# UNITED STATES PATENT AND TRADEMARK OFFICE

10/551,629

## Office Action Summary

## **DETAILED ACTION**

(Meeske Figure 1 and Figure 2)

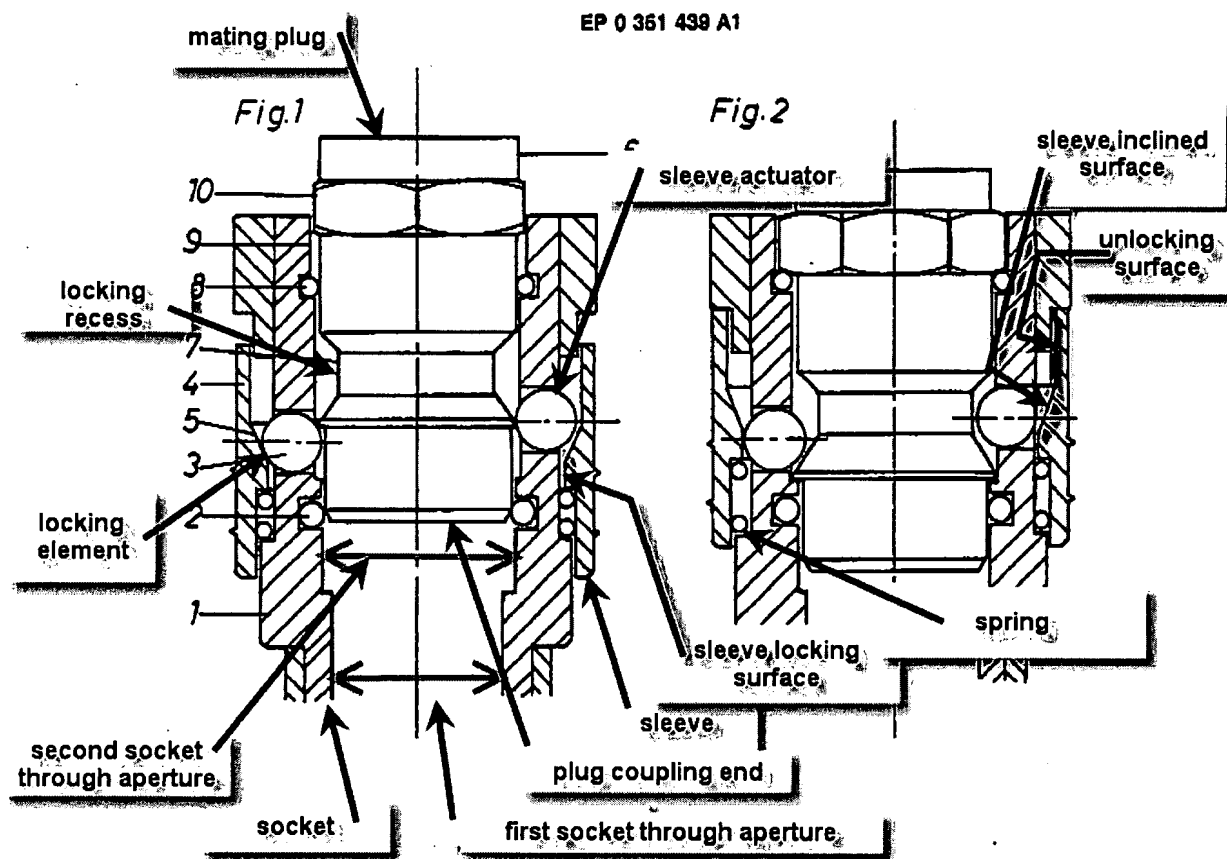
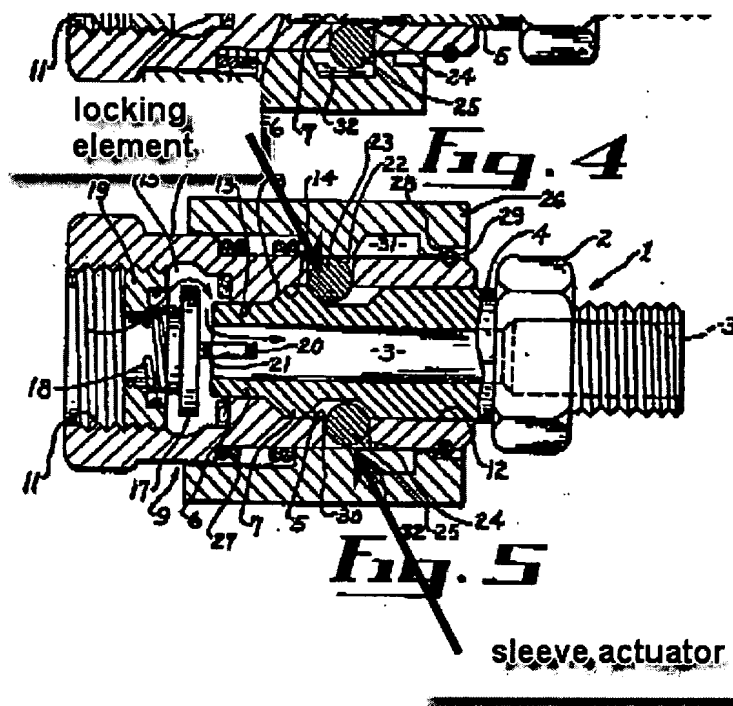
15. In regard to claims 1 and 7, Meeske discloses in Figure 1 and Figure 2, below, a pipe coupling comprising

a cylindrical socket body (1) having a first through aperture extending radially therethrough (as observed in Figure 1, below);

a locking element (the ball 3 furthest from the plug in Figure 1, below) radially movable within the first through aperture, the locking element being movable between a first radial position wherein the locking element is engaged with a locking recess (7) on the plug (as observed in Figure 2 and column 2, lines 31-35) so as to inhibit disconnection of the plug from the socket and a second radial position wherein the locking element is radially outwardly displaced from the first radial position and disengaged from the locking recess (as observed in Figure 1) to allow disconnection of the plug from the socket;

the coupling end of the plug being slidably engaged with the locking element located in the first radial position to cause radial outward movement of the locking element when the plug is inserted into the socket (as observed in Figure 1),

the socket body comprises a second through aperture (as observed in Figure 1, below) located axially closer to the plug than the first through aperture and extending radially therethrough and a sleeve actuator (as observed in Figure 1, below) disposed in the second through aperture and movable between a radially inward position wherein the sleeve actuator is

the sleeve has an inclined surface (as observed in Figure 1, below) inclined radially outwardly from the locking surface toward the unlocking surface, the inclined surface being engaged with the sleeve actuator when the sleeve is located in the locking position, the coupling end of the plug being engaged with the sleeve actuator upon insertion of the plug into the socket so that the sleeve actuator is radially outwardly moved to thereby cause axial movement of the sleeve against the bias of the spring, wherein when the coupling end of the plug is brought into engagement with the locking element during advancement of the plug, the inclined surface is moved to a radially outward position relative to the locking element, the coupling end of the plug radially outwardly urging the locking element against the inclined surface of the sleeve upon further insertion of the plug, thereby causing further axial movement of the sleeve (the invention of Meeske has the structure to so perform the functional recitation as can be observed in Figure 1 and Figure 2, below).

FIG. 1

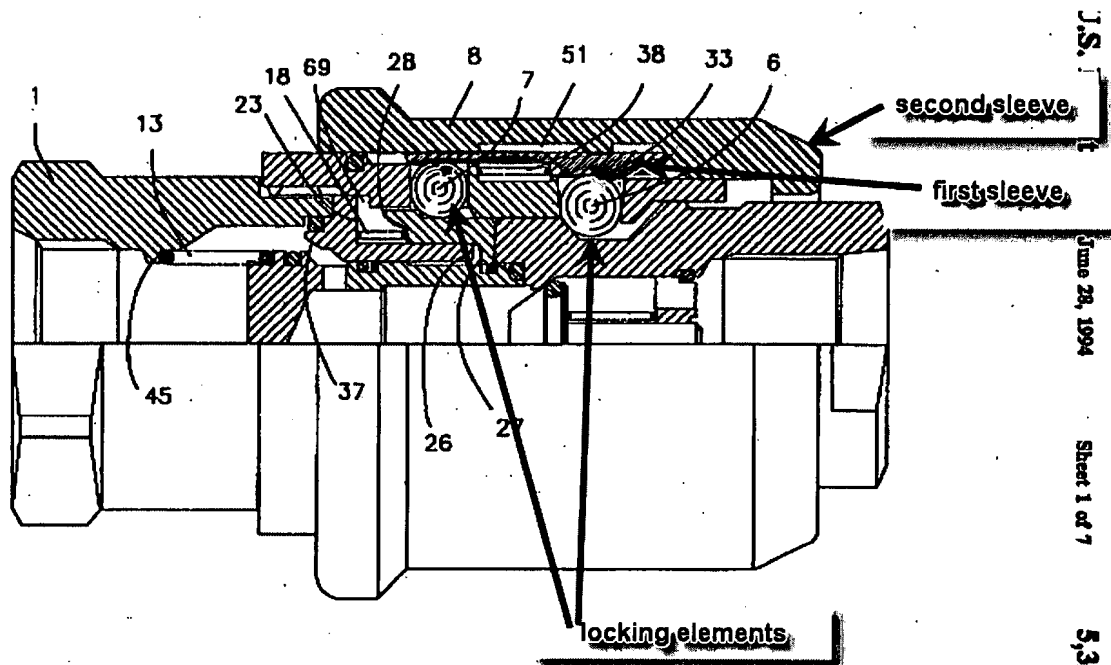
20. In regard to claims 3 and 8, Meeske discloses the claimed invention except for the sleeve comprising two sleeve elements and a stopper feature. Wayne teaches a pipe coupling with locking elements (6, 7) in Figure 1, below, wherein the sleeve comprises two elements (5, 8) to provide a quick disconnection of the coupling with a releasable locking sleeve (column 1, lines 38-41). As Wayne relates to pipe couplings with locking elements, it would have been obvious to one having ordinary skill in the art at the time the invention was made to modify the pipe coupling of Meeske with the sleeve comprising two sleeve elements as taught by Wayne to provide a quick disconnection of the coupling with a releasable locking sleeve.

(Mullins Figure 6 and Figure 7)

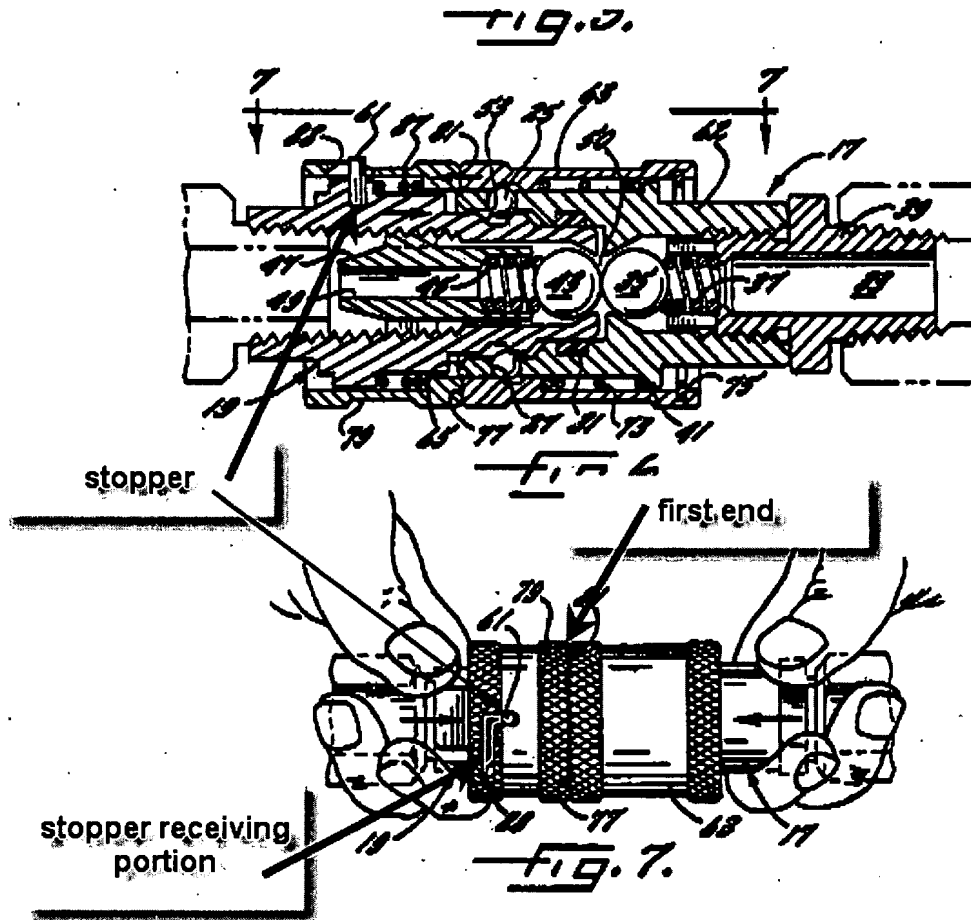
21. Further in regard to claims 3 and 8, Meeske in view of Wayne provides for the claimed invention except for a stopper feature. Mullins teaches a pipe coupling with locking elements in Figure 6 and Figure 7, below, with a stopper structure (pin 61 and slot 88) arranged on a coupling member, the stopper allowing a spring biased sleeve (79) to rotate between two angular positions and prevent axial movement of the sleeve at one of the axial positions (column 7, lines 48-52), to substantially preclude inadvertent uncoupling of the plug and the socket from coaxial relation (column 7, lines 45-52). As Mullins relates to pipe couplings with locking elements, it would have been obvious to one having ordinary skill in the art at the time the invention was made to modify the sleeve as provided for by Meeske in view of Wayne with the stopper structure as taught by Mullins to substantially preclude inadvertent uncoupling of the plug and the socket from coaxial relation

25. Claims 6, 9, 10, and 11 rejected under 35 U.S.C. 103(a) as being unpatentable over Meeske in view of Wayne and Mullins as advanced above.
26. In regard to claims 6, 9, 10, and 11, Mullins, in Figure 6 and Figure 7, above, provides:

- the sleeve (79) having a first end adjacent to the plug (19) and a second end remote from the plug,
- wherein the stopper receiving portion includes a slot (88) extending from the second end toward the first end of the second sleeve,

- wherein the stopper (61) extends radially outwardly from the fitting (as observed in Figure 6)
27. Mullins is silent as to how his teachings would be applied to the structure of the pipe coupling of Meeske in view of Wayne. However, as Mullins teaches that the stopper structure is to substantially prevent uncoupling of the plug and socket (column 7, lines 45-52). Therefore, it would have been obvious to one having ordinary skill in the art at the time the invention was made to choose a stopper structure such that the stopper would be engaged with the second end

(Wayne cut-out of Figure 1)

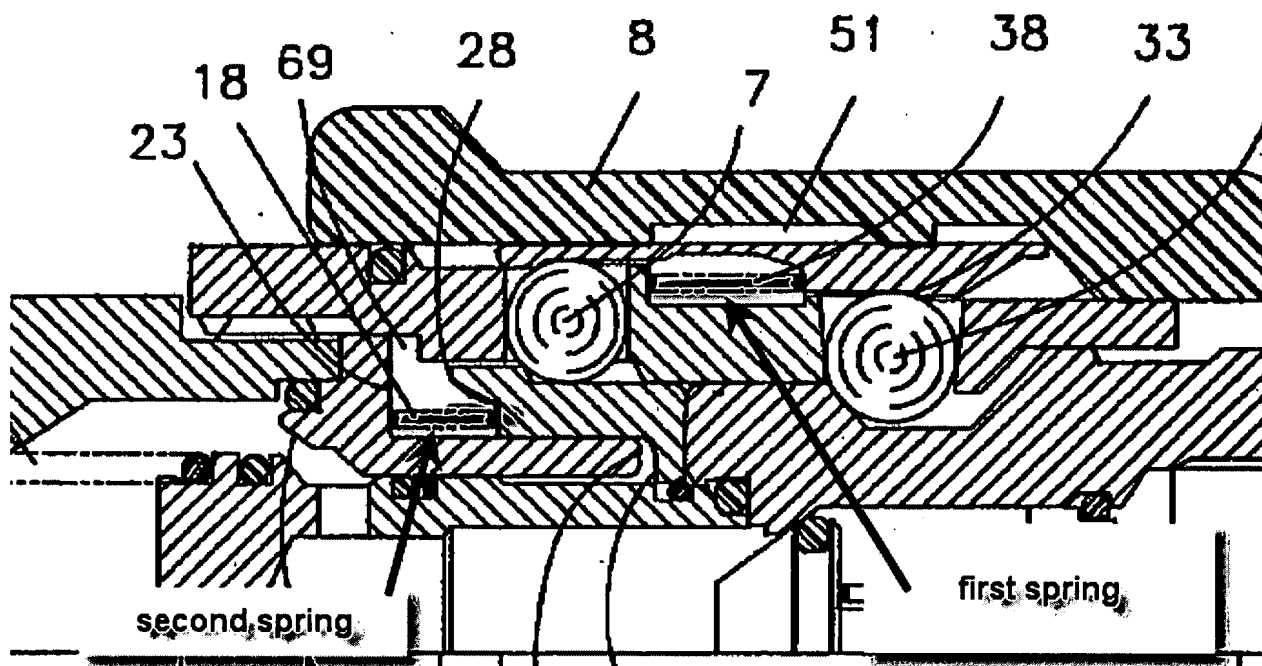
23. In regard to claim 4, Meeske in view of Wayne and Mullins provide for the claimed invention including a second spring. Wayne further teaches a second spring (18), as observed in cut-out of Figure 1, below, to urge the sleeve toward the locked position (column 4, lines 18-20). As Wayne relates to Wayne relates to pipe couplings with locking elements, it would have been obvious to one having ordinary skill in the art at the time the invention was made to further

(Meeske cut-out of Figure 1)

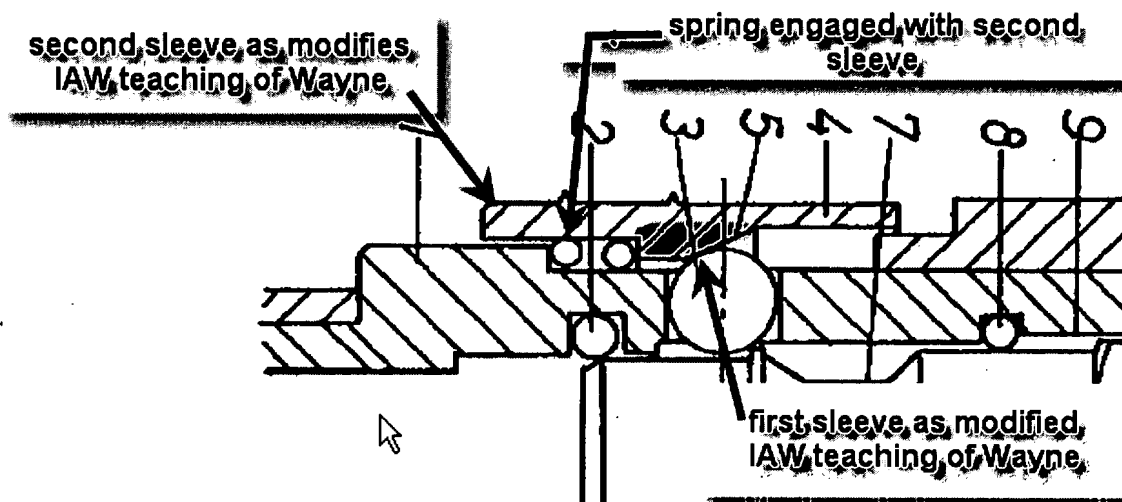
24. In regard to claim 5, Meeske further provides for a coil spring disposed around the socket body having one end located at one position on the socket body and engaged with the first sleeve to urge the first sleeve toward the locking position, and an other end engaged with the second sleeve (a coil spring as indicated by the symbol used in Meeske Figure 1, a cut-out shown below, the recognized technical drafting symbol for a coil spring).
